BOARD OF COMMISSIONERS

September 17, 2025 - 7:30 PM

ITEM: PRELIMINARY LAND DEVELOPMENT PLAN - 1 Belmont Avenue, Bala Cynwyd, Ward 9, LD# 3925PP

SUBJECT: PRELIMINARY LAND DEVELOPMENT PLAN
1 Belmont Avenue, Bala Cynwyd, Ward 9, LD# 3925PP

1. Architectural Design

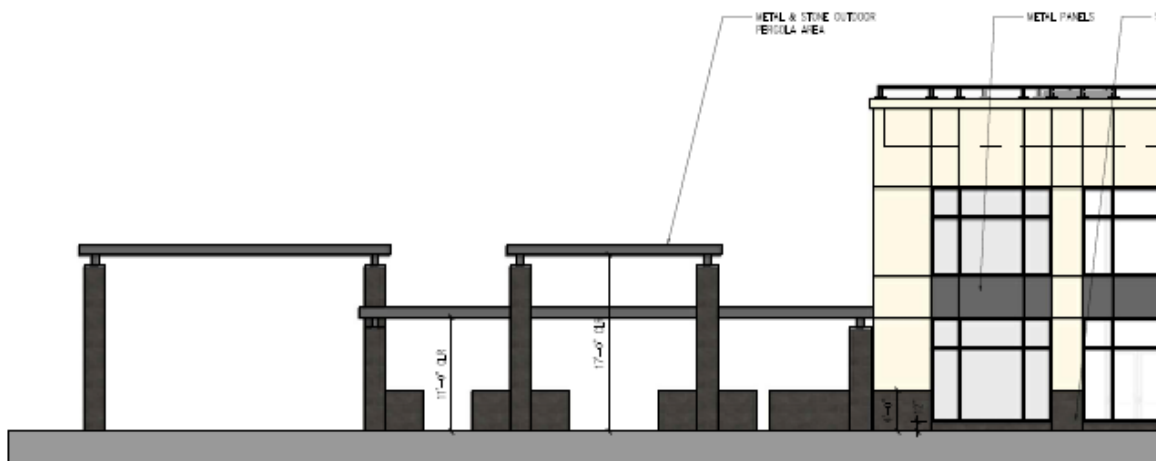
The architectural design elements included on the applicant's most recent submission aim at creating a gateway design at the City/Belmont corner. Opportunities may exist to further enhance the gateway and to create a more impactful pedestrian-oriented design that is integrated with landscaping and streetscape features through the use of material selection, façade articulation, wrapped awnings, and signage placement.

- RCA 5. The applicant shall continue to work with staff on the overall architectural design of the structures, particularly Building 2, to ensure that the design adequately recognizes the site's importance as a Township and City Avenue gateway and to better align with the intent of the architectural design standards stated in §155-6.6(l)(5) and §155-3.9.

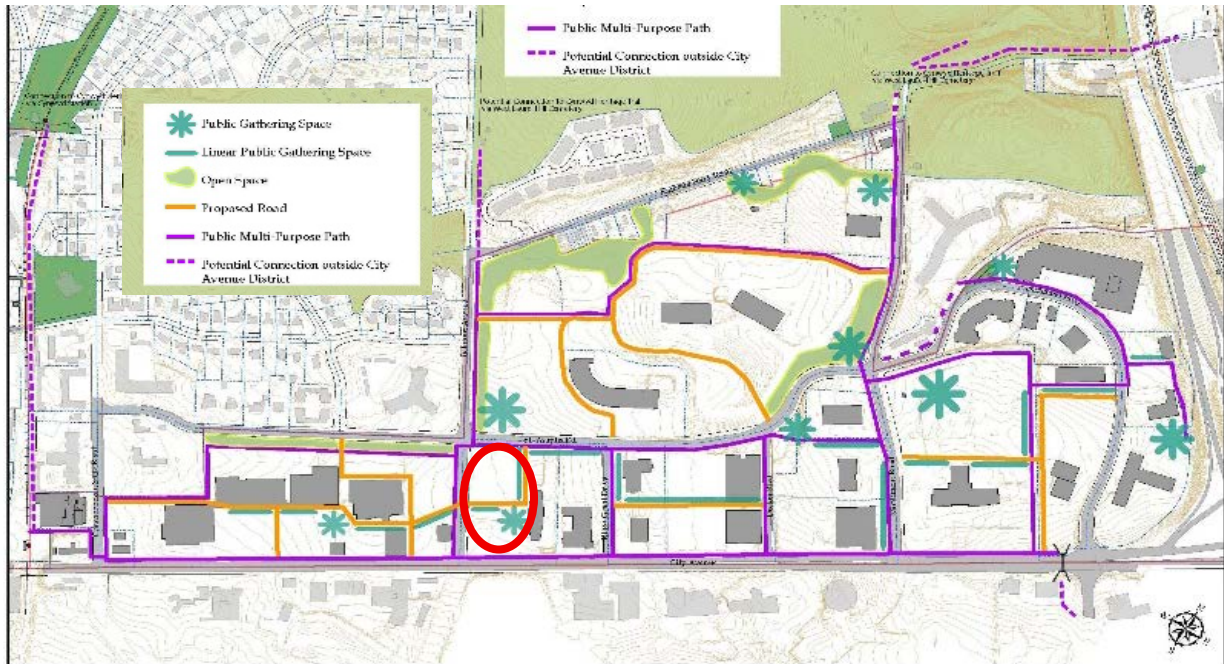
The design of Building 1 as shown here along the West Road facade effectively uses a pergola extension to create a pedestrian-scale environment.

The previously approved land development for the Property demonstrates a thoughtful pedestrian-oriented design including an at-grade primary facade entrance, pedestrian-scale signage and unique awning and window frame color.

- RCA 7. The applicant shall consider increasing the pedestrian scale of the overall plan through the use of pergola extensions along street frontages from each of the three structures.

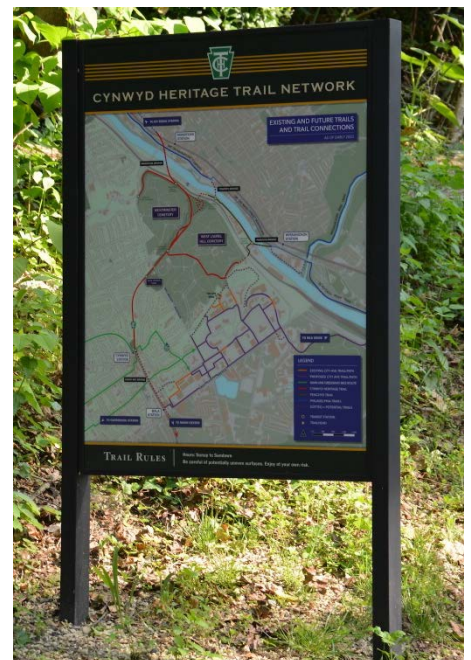
The proposed public gathering space will be a centrally located within in the district as shown on the City Avenue District Official Map below and will complement the existing and future planned network of trails and pedestrian oriented spaces. With the presence of a rapidly growing residential community and active on-site and nearby office and commercial uses, the Property's public gathering space will be an axis of activity that will be accessible by a short walk or bike ride for many. Opportunity exists for future programming including the Bala Cynwyd Farmer's Market and other community events.

- RCA 55. The Applicant shall work with staff and the City Avenue District to design and install Wayfinding signage and Entry Plaque Signage to support the public gathering space and public trails. Wayfinding signage shall show the location of the proposed public gathering space and trails in relation to the City Avenue District, Cynwyd Trail and Pencoyd Landing trail networks, and include residential and commercial landmarks, bike share/transit infrastructure and locations accessible to the open space/trail network.
